SIM 34 01 24

RECALL 24V-104: INTEGRATED BRAKING SYSTEM (IB)

This Service Information Bulletin (Revision 7) replaces SI M34 01 24 **dated November 2024**.

This Service Information Bulletin (Revision 8) replaces SI B34 02 24 **dated November 2024**.

“Wet” IB pre-filled: Brake fluid reservoir is filled (arrow) and brake fluid line ports are plugged with bolts (circled)

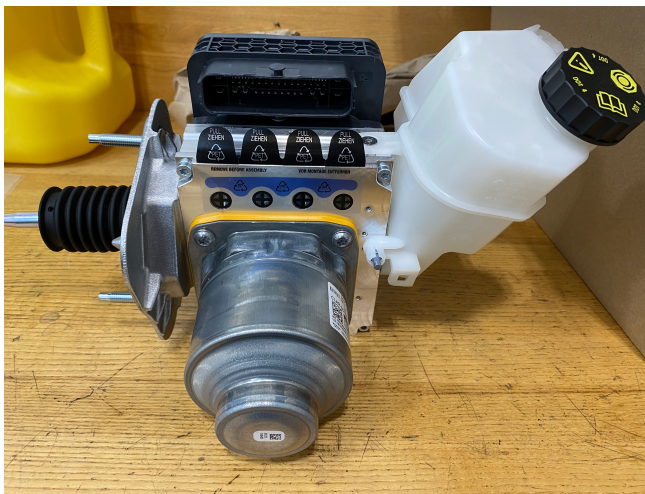
- Correction updated (some previous part numbers deleted)
- Procedure updated
- Parts Information revised
- Claim Information revised
- Attachments for “Wet IB” and “Dry IB” from Revision 6 no longer needed

Replace the IB with either a “wet” pre-filled unit or a “dry” unfilled unit.

“Dry” IB unfilled: Brake fluid reservoir is empty; brake fluid line ports are sealed with labels.

If you have received a **“wet”** unit, follow the REP34 51 601 Replacing hydraulic unit.

If you have received a **“dry”** unit, follow the REP 34 51 602 Replacing the hydraulic unit (not filled).

Prior to connecting the negative battery cable as per the REP instructions follow up works step 23, manually fill the brake fluid reservoir to just below the rim of the filler, above the “MAX” mark. Reinstall the fluid reservoir cap and continue REP procedures

“Wet” IB pre-filled: Brake fluid reservoir is filled (arrow) and brake fluid line ports are plugged with bolts (circled).

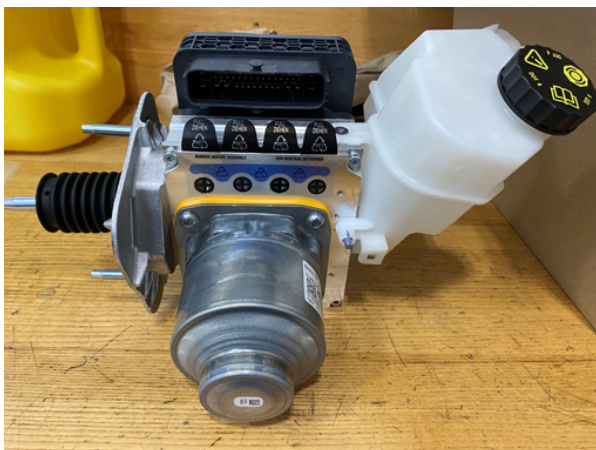
- Correction updated
- Procedure revised
- Parts Information updated
- Claim Information updated
- Attachments for “Wet IB” and “Dry IB” from Revision 7 no longer needed

Replace the IB with either a “wet” pre-filled unit or a “dry” unfilled unit.

“Dry” IB unfilled: Brake fluid reservoir is empty; brake fluid line ports are sealed with labels.

If you have received a “**wet**” unit, follow the REP34 51 601 Replacing hydraulic unit

If you have received a “**dry**” unit, follow the REP 34 51 602 Replacing the hydraulic unit (not filled).

Prior to activating the high-voltage or low-voltage electrical system as per the REP instructions, manually fill the brake fluid reservoir to just below the rim of the filler, above the “MAX” mark.
